V2500-A1 PROPULSION SYSTEMS SERVICE BULLETIN

V2500-ENG-72-0422

ENGINE – HP COMPRESSOR VARIABLE VANE INNER SHROUDS – INTRODUCTION OF REVISED ONE
PIECE BUSHES

Repair details and dimensions
Fig.1

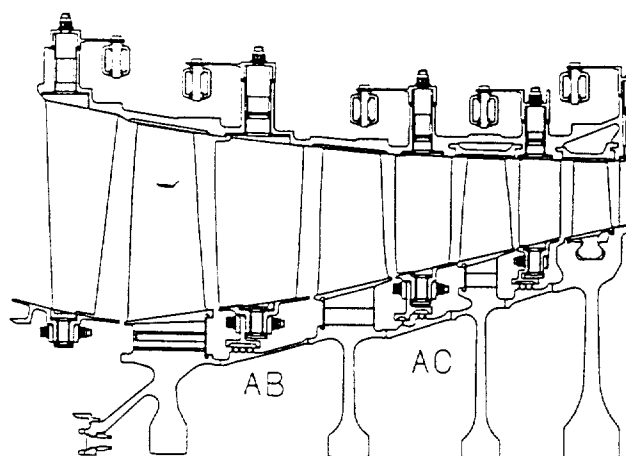
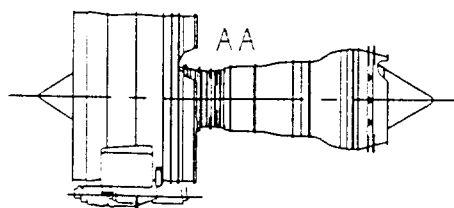
- (a) A revised one piece HP Compressor VSV inner spindle bush is introduced replacing the existing two piece bush across VIGV, stage 3, stage 4 and stage 5, similar to the existing item except for the following:

- (i) The graphite/polymide material is changed from Vespel SP211 to Vespel ST2030.
 - (ii) The inner and outer diameters have been changed to suit the thermal properties of the revised material.

- (b) Revised HP Compressor VIGV, stage 3, stage 4 and stage 5 vanes are introduced, similar to the existing items except for the following:
- (i) The penny at the base of the vane spindle is deleted to suit the one piece bush.

Repair details and dimensions
Fig.2

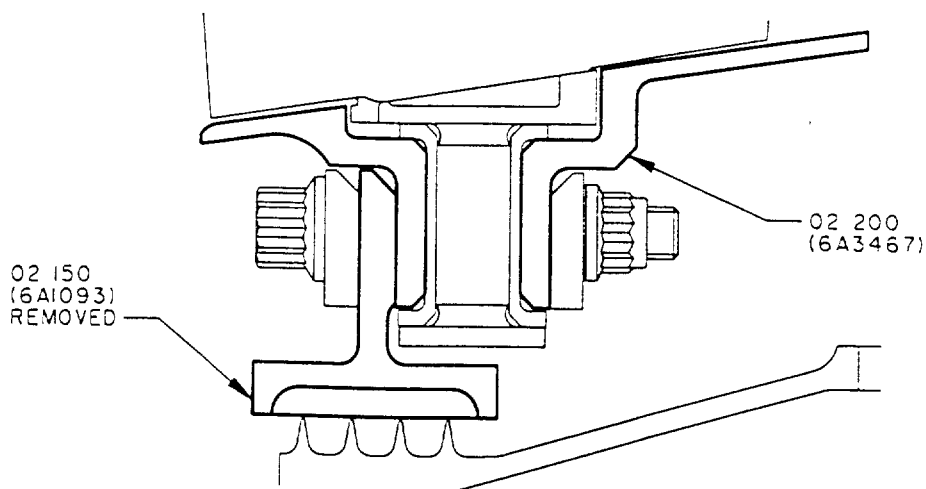
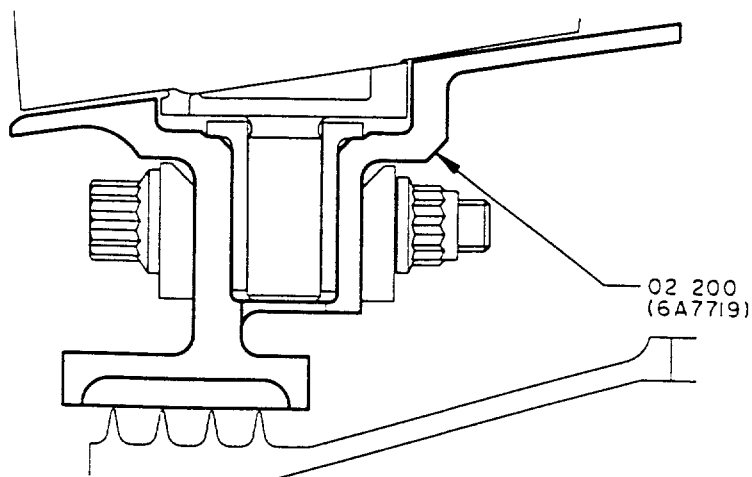
- (ii) The inner spindle hole diameter is increased to suit the revised one piece bush.
- (d) A revised HP Compressor stage 3 shroud half assembly is introduced, similar to the existing item except for the following:-

- (i) A lip is introduced to the inner spindle hole as a retention feature for the bush.
 - (ii) The inner spindle hole diameter is increased to suit the revised one piece bush.

- (iii) Revised location pins and retaining rings are introduced.
 - (iv) The stage 3 inner static seal is now an integral part of the shroud half assembly.

- (e) As described above, the stage 3 inner static seal is deleted as a separate item, the features are now incorporated within the stage 3 shroud half assembly.

- (f) Revised stage 3 inner shroud attaching bolts are introduced similar to the existing item except for a reduction in length.
- (g) A revised HP Compressor stage 4 shroud half assembly is introduced, similar to the existing item except for the following:

Repair details and dimensions
Fig.3

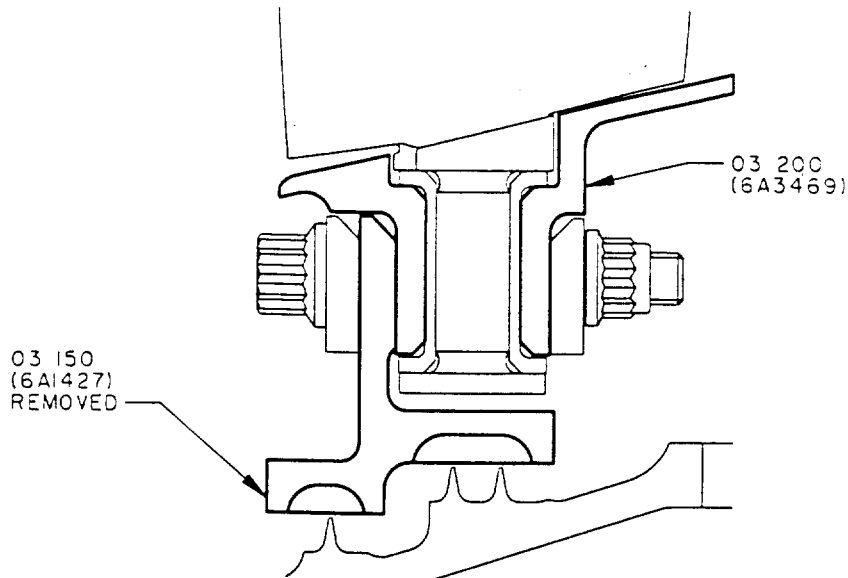
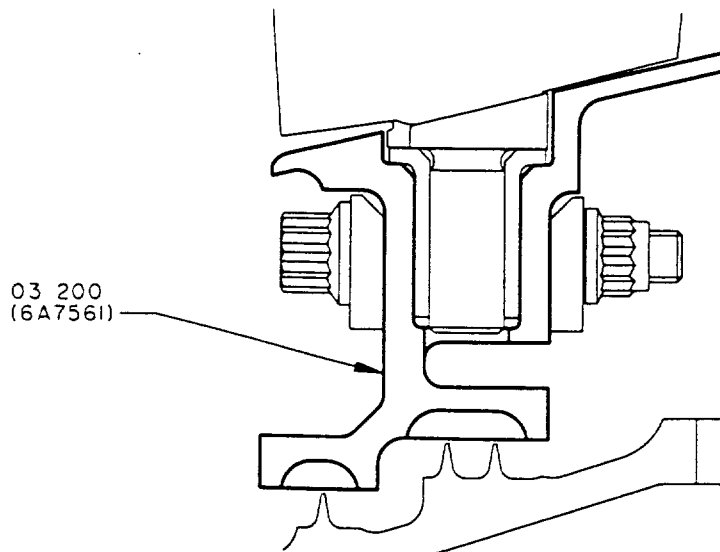
- (i) A lip is introduced to the inner spindle hole as a retention feature for the bush.
 - (ii) The inner spindle hole diameter is increased to suit the revised one piece bush.

- (iii) Revised location pins are introduced.
 - (iv) The stage 4 inner static seal is now an integral part of the shroud half assembly.
- (h) As described above, the stage 4 inner static seal is deleted as a separate item, the features are now incorporated within the stage 4 shroud half assembly.

- (i) Revised stage 4 inner shroud attaching bolts are introduced, similar to the existing item except for a reduction in length.
- (j) A revised HP Compressor stage 5 shroud half assembly is introduced, similar to the existing item except for the following:

Repair details and dimensions
Fig.4

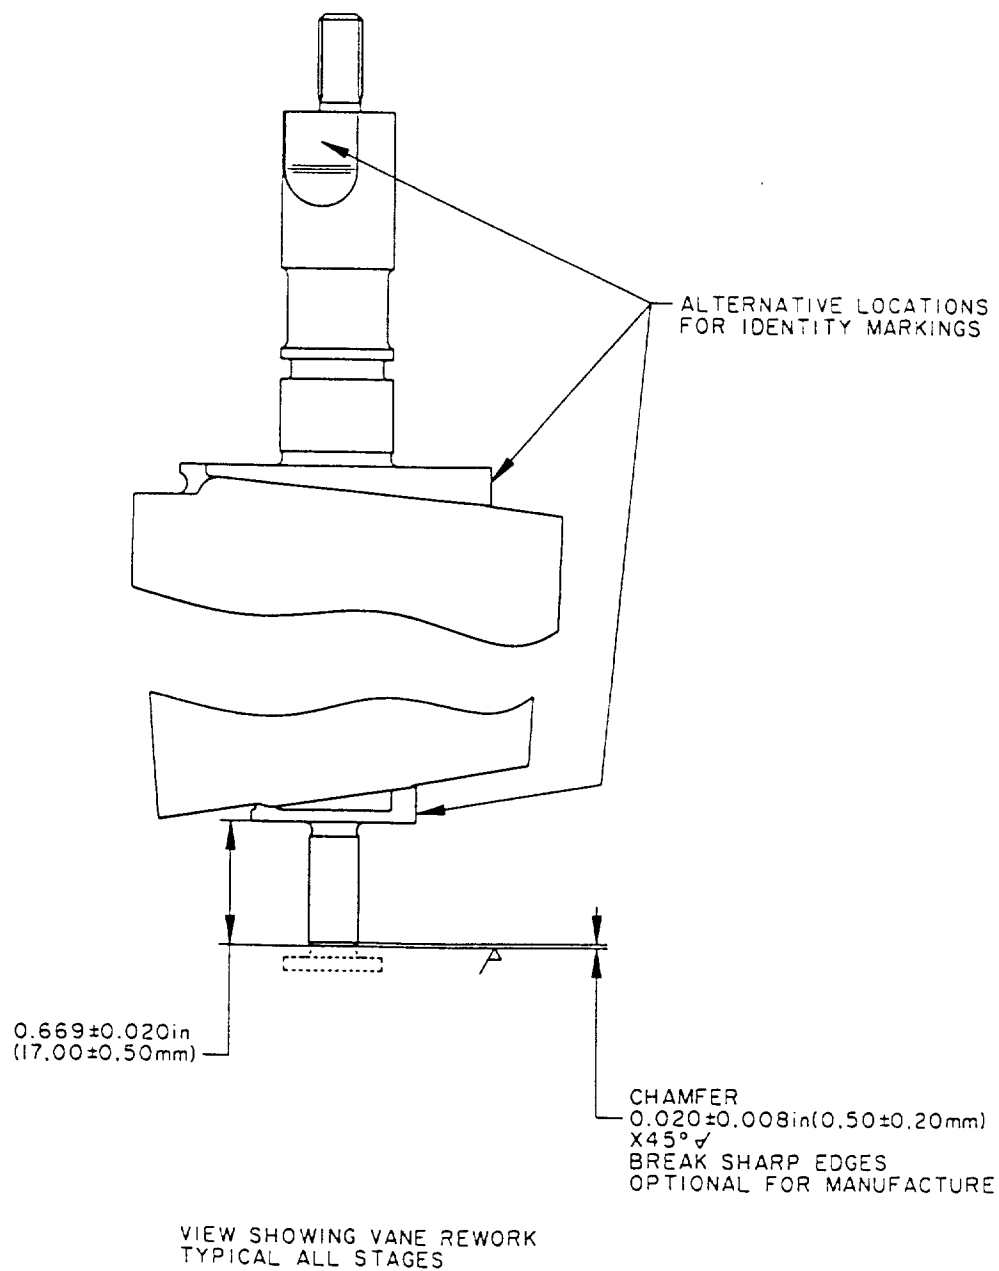
- (ii) Machine the VIGV to length

- (iii) Machine the chamfer on the VIGV

(ii) Machine the vanes to length

(iii) Machine the chamfer on the vanes

MACHINE WHERE MARKED ✓
SURFACE FINISH TO BE 125 MICROINCHES (3.2 MICROMETRES)
